Annex 91A

Coexistence of 1 Gb/s (symmetric), 10 Gb/s (symmetric) and 10/1 Gb/s (asymmetric) Ethernet Passive Optical Networks (EPONs)

Figure 91A-2—Reconciliation sublayer for dual rate mode at OLT.

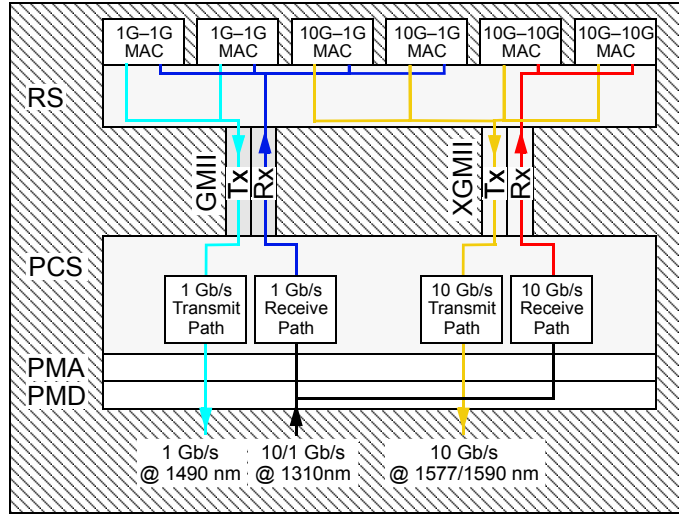
To support coexistence of ~~symmetric~~symmetric 10 Gb/s, ~~asymmetric~~asymmetric 10/1 Gb/s, and legacy 1 Gb/s ONUs on the same outside plant, the OLT may be configured to use a dual-rate mode. Dual-rate mode supports transmission and reception at both 10 Gb/s and 1 Gb/s ~~ss via TDMA~~. When operating in a dual-rate mode, a combination of XGMII and GMII data paths are used for transmission and reception. Figure 91A-2 depicts ~~the reoneiliation sublayer~~OLT stack operating in a dual-rate mode.

Figure 91A-4—Combinations of REGISTER_REQ MPCPDUs during discovery window for 10G-EPON and EPON coexisting on the same PON.

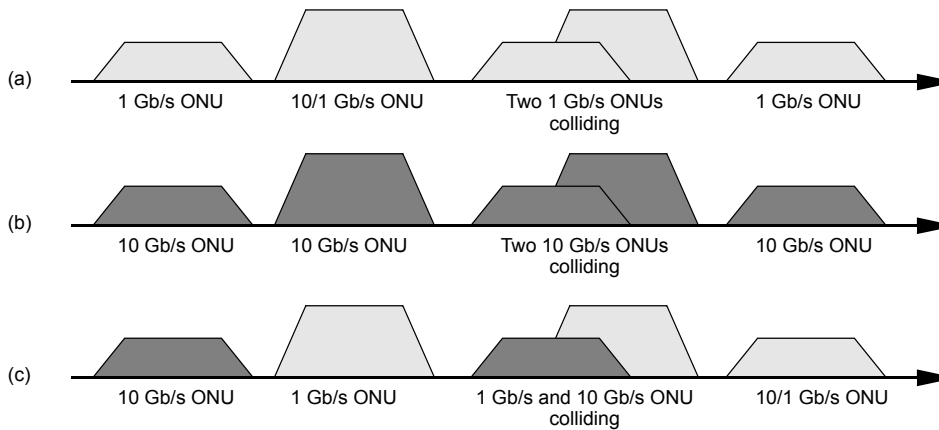
Figure 91A-4 shows the three primary combinations of discovery windows and the different types of ~~Regis-~~ ter ~~Request messages~~ REGISTER_REQ MPCPDUs that may be received during the window. Figure 91A-4(a) shows reception of messages from 1 Gb/s and 10/1 Gb/s ONUs. Figure 91A-4(b) shows reception of messages from 10 Gb/s ONUs. Figure 91A-4(c) shows reception of messages from all types of ONUs.

Figure 91A-5—Dual-rate PMD topologies with the split in the (a) optical domain, (b) electrical domain.

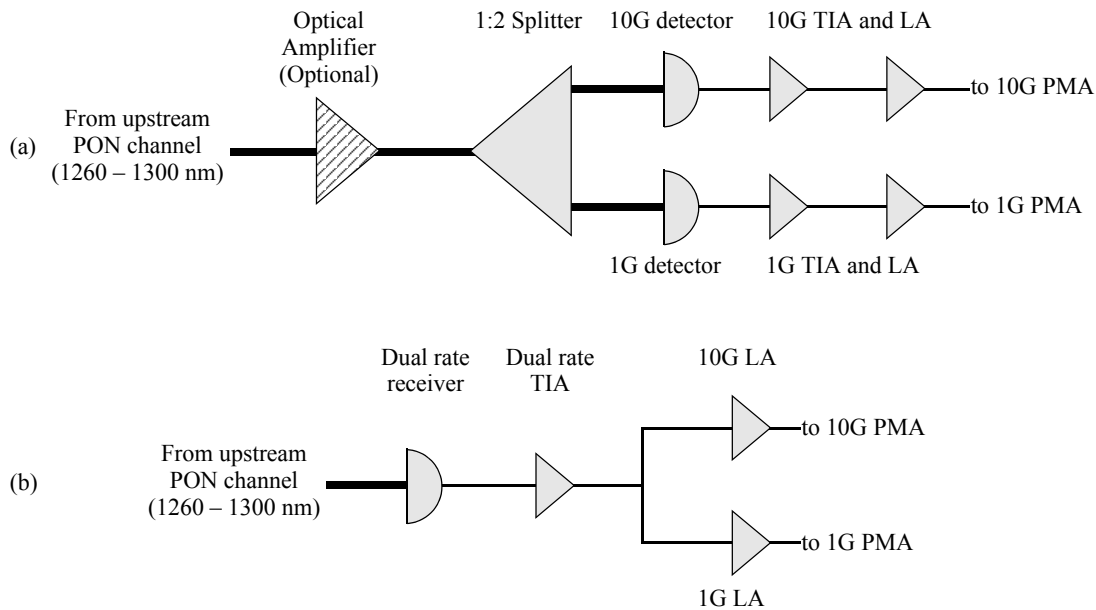
When the incoming signal is split in the optical domain, it is possible to design each PMD channel specifically to match the signaling speed, offering optimum sensitivity for both 1 Gb/s and 10 Gb/s signals. However, the additional 1:2 optical splitter presented in Figure 91A-5(a) will reduce the sensitivity of the following photodetectors by introducing additional loss and lowering the power of the optical signal. Such a sensitivity reduction may be tolerable in the PX10/PRX10/PR10 type PMDs, but the more stringent power budgets including PX20, PR20, PRX20, PR30 and PRX30 may be very challenging or even impossible to implement with such an additional loss on the OLT receiver side. This particular problem may be resolved via an additional, low-gain optical amplifier introduced in-line with the 1:2 optical splitter, as presented in Figure 91A-5(a), used to boost the power level of the incoming signal sufficiently to overcome the loss introduced by the 1:2 optical splitter.

The electrical domain, only one photodetector and one TIA units are used, and. The resulting optical sensitivity can be theoretically maintained in theory without the need for optical amplification, reducing the complexity of the OLT receiver. However, the detector-photodetector and TIA must cope with both data rates in quick succession, switching between 1 Gb/s and 10 Gb/s bursts during the guardband. The key aspect here is that the detector-TIA bandwidth directly affects the sensitivity. If the circuit parameters of the detector-TIA can be rapidly adapted to the correct value, optimum sensitivity can be maintained. There are three implementation choices in this regard, as shown in Figure 91A-5(a)-(c):

Figure 91A-6—Dual rate APD-TIA architectures: (a) static, (b) half-dynamic, (c) fully-dynamic

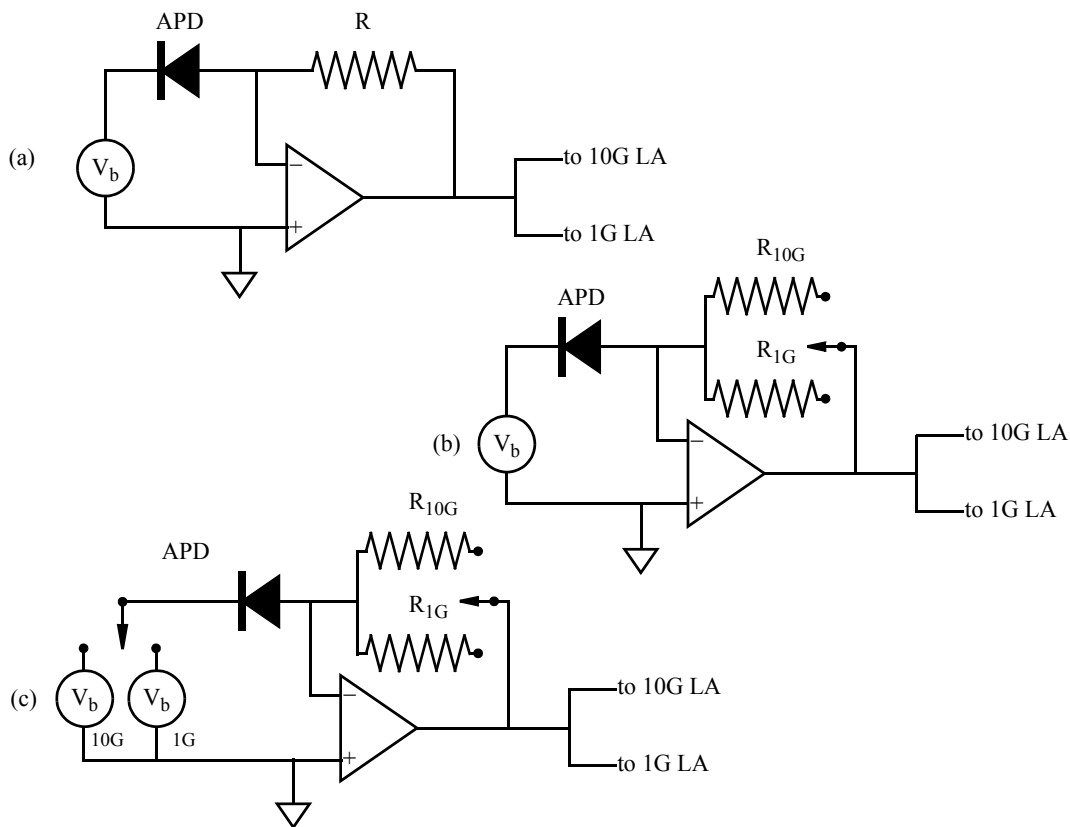
- a) The option (a) This design fixes the detector parameters at some predefined value. This results, resulting in a sensitivity the reduction of about the OLT receiver sensitivity by approximately 2 dB; however. However, it should be noted that this penalty can be divided in such a way that both the 1 Gb/s and 10 Gb/s sensitivities are 1 dB less-lower than their ideal values.

- b) The option (b) This design fixes the APD bias, but switches the TIA transimpedance depending on which the target signaling speed is desired. This results for the given incoming burst, resulting in a sensitivity the reduction of about the receiver sensitivity by approximately 1 dB. Said reduction-The said sensitivity penalty could be subdivided over-to both data rate channels by setting the APD bias to a compromise value.

- c) The option (c) This design switches both the APD bias and the TIA transimpedance depending on the signaling speed speed of the incoming burst. This results in ideal performance at both speeds 1 Gb/s and 10 Gb/s data rates. However, it is the most complex-complex design in terms of the number of elements and the control complexity, and it is unclear if the benefits outweigh the costs.
